Access Compliance Report Public Rights-of-Way (Curb Ramps)

Main Street: VINE_ST Cross Street: HEWES_ST Location: NW

ADA ID: RPAT210929092334 Ramp Type: Type 4 - Parallel Initial Pass/Fail: Fail Overall Compliance: No Severity Score: 19

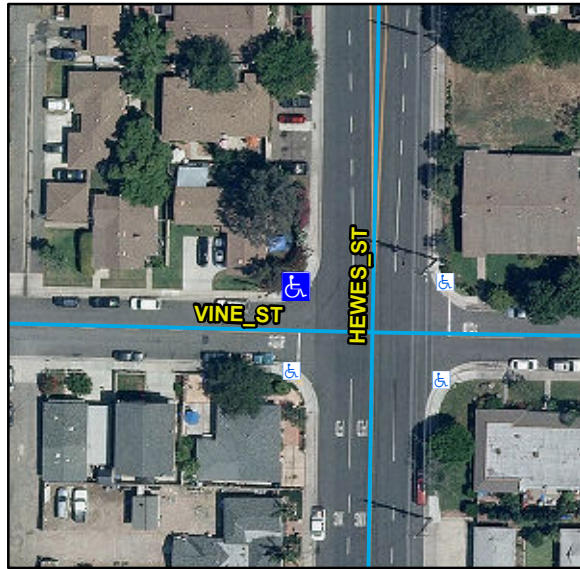
Compliance	Description	Data	Compliance	Description	Data
N/A	Ramp Length LT (in)	71	N/A	Ramp Length RT (in)	116
Yes	Ramp Width LT (in)	48	No	Ramp Width RT (in)	47
Yes	Ramp Run Slope LT (%)	0.2	No	Ramp Run Slope RT (%)	8.9
Yes	Ramp Cross Slope LT (%)	0.5	Yes	Ramp Cross Slope RT (%)	0.6
N/A	Landing Present	N/A	N/A	DWS Provided	N/A
N/A	Landing Length (in)	N/A	N/A	DWS Contrast	N/A
N/A	Landing Width (in)	N/A	N/A	DWS Length (in)	N/A
N/A	Landing Run Slope (%)	N/A	N/A	DWS Full Width	N/A
N/A	Landing Cross Slope (%)	N/A		DWS Offset Type	N/A
N/A	Landing Movement Obstructed?	N/A	N/A	DWS Offset Left (in)	N/A
	Landing Movement Type	N/A	N/A	DWS Offset Right (in)	N/A
N/A	Landing Shared	N/A			
N/A	Clear Space	Yes			
N/A	Clear Space To Crosswalk (in)	N/A			
N/A	Marked Crosswalk 1	No	N/A	Marked Crosswalk 2	No
	Crossing 1 Direction	S		Crossing 2 Direction	E
	Marked Crosswalk 1 Width (in)	N/A		Marked Crosswalk 2 Width (in)	N/A

Remove & Replace Curb Ramp With Two New Directional Ramps or Equivalent.
